Access Compliance Report

Public Rights-of-Way

(Curb Ramps)

Intersection ID: 43730	Main Street: TIFFANY_ROSE_PL	Cross Street: W_CRAIGHEAD_RD	Location: SE
ADA ID: 24FFE0FAEE2D	Ramp Type: BlendTrans1	Initial Pass/Fail: Fail	Overall Compliance: No
Severity Score: 8.75			
Codes/Mitigation Info/Possible Solution		Field Measurements/Component Compliance

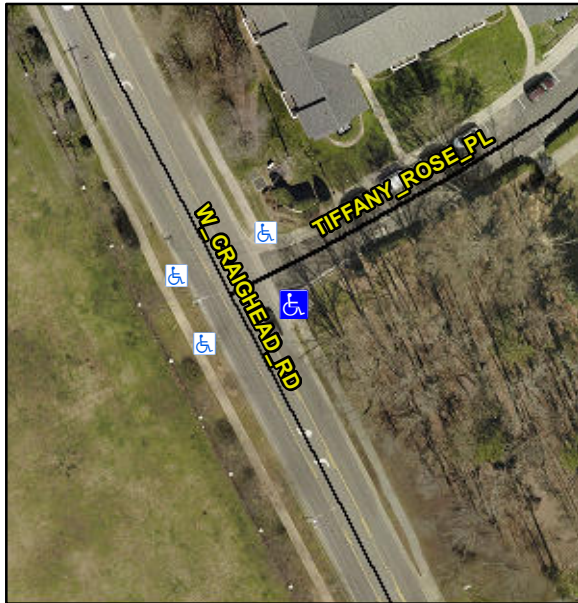
CURB LIP 1.0, NO LT SW

Not Found, R304.5.1

Remove & Replace Curb Ramp With Two New Directional Ramps or Equivalent.
